NUMBER: B389R1068-A

## SERVICE BULLETIN

36' CARROUSEL

Subject: Inspection of Horse Hanger Hooks, Bearings, Horse Pipe, Telescope Assemblies, and Crankshaft Throws

ILLUSTRATION A

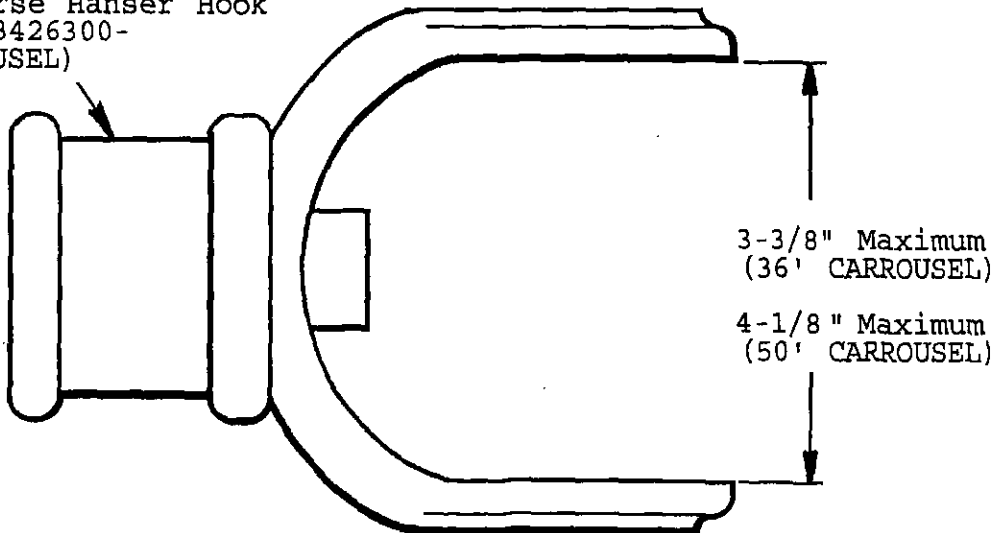
Chance Rides, Inc. requires that all CARROUSEL owners inspect the horse hanger hooks, the horse hanger hook bearing, the horse pole, the telescope assemblies and crankshafts to ensure that all parts fit properly within the wear tolerances for a safe ride.

Perform the following inspection at each set-up, or monthly, whichever occurs first.

MG-70 Horse Hanger Hook  
Part No. 33424000  
(36' CARROUSEL)

370-101 Horse Hanger Hook  
Part No. 33426300-  
(50' CARROUSEL)
